Staff Report & Recommendation

Historic Preservation Board

SUBJECT: HPB19-0299, **4333 Collins Avenue – Holiday Inn Miami Beach Oceanfront.**

An application has been filed requesting a Certificate of Appropriateness for the construction of a 1-story rooftop addition including a variance from the required interior side setback.

Aerial view looking north, proposed hotel room addition outlined

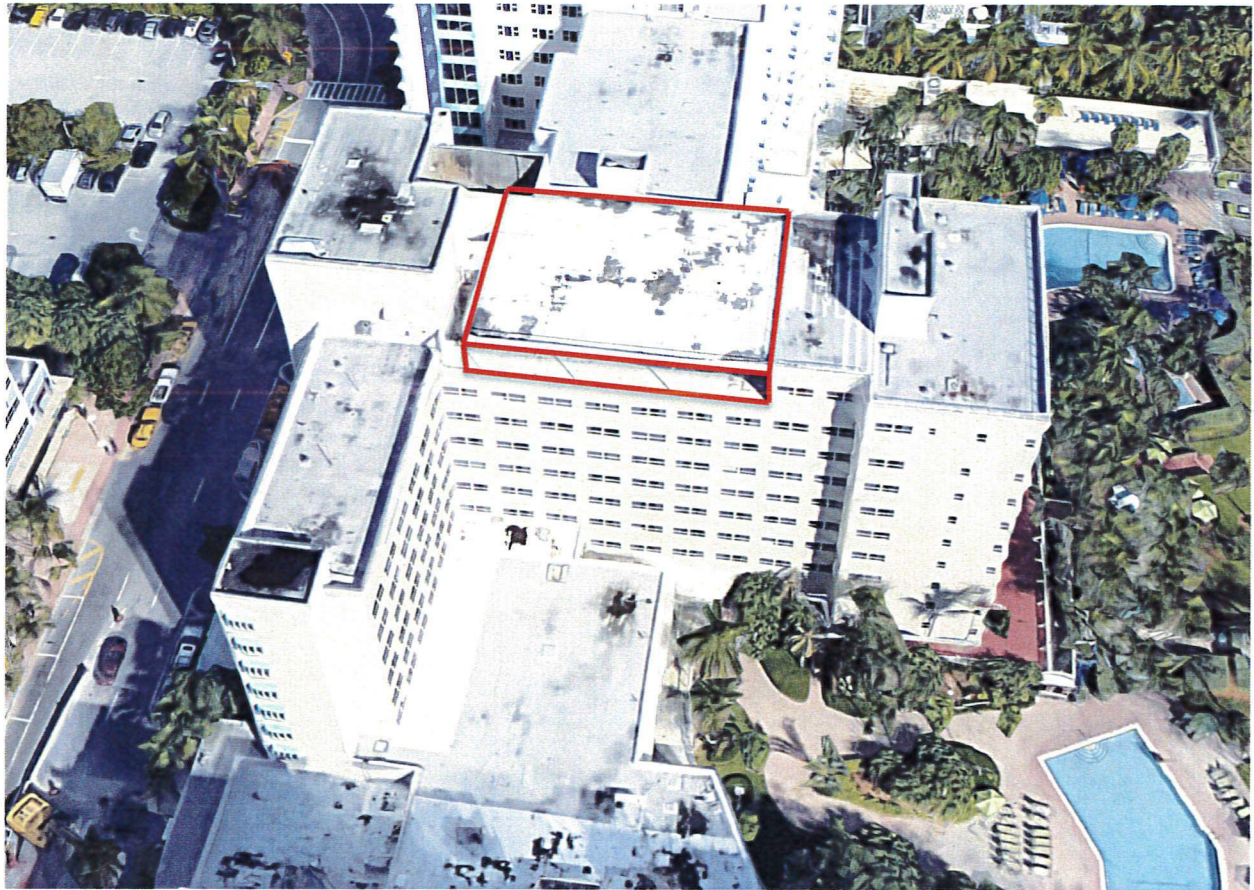
The subject structure, originally known as the Empress Hotel, was constructed in 1952 and designed by Melvin Grossman in the Post War Modern style of architecture. The applicant is currently proposing the construction of a partial 1-story roof top addition containing 12 new guest rooms. The proposed addition will enclose an existing covered rooftop area at the east wing of the building (see image on following page). This area has an existing concrete roof but is open on the north and south sides. The addition has been designed in a minimalist architectural vocabulary that is compatible with the underlying building and follows the existing building footprint. Further, the rooftop addition is entirely out of the Collins Avenue line-of-sight. As such, staff is supportive of the modest rooftop addition and recommends approval as noted below.

The applicant is requesting a variance to reduce the required setback at the tower level (above 50'-0" from the first finish floor) for the construction of new hotel units. The area is contained within the building profile with minimal impact on the existing structure. The new floor area is proposed in a covered terrace open to the interior of the site between existing front and rear structures. The front and rear portions of the building have a setback of approximately 5'-0" from the property line, the middle portion, where the units are proposed have a setback of 14'-4", which is a much larger side setback than many of the surrounding buildings. The existing building configuration and setbacks creates the practical difficulties that justify this variance request for which, staff has no objections. The addition will not maximize the property's FAR and will not have any negative impact on the existing structure or the historic district. In summary, staff finds that the applicant's request satisfies the practical difficulties criteria of the City Code for the granting of a variance.

In view of the foregoing analysis, staff recommends the application be **approved** as to the Certificate of Appropriateness and variance request, subject to the conditions enumerated in the attached draft Order, which address the inconsistencies with the aforementioned Certificate of Appropriateness criteria and Practical Difficulty and Hardship criteria, as applicable.
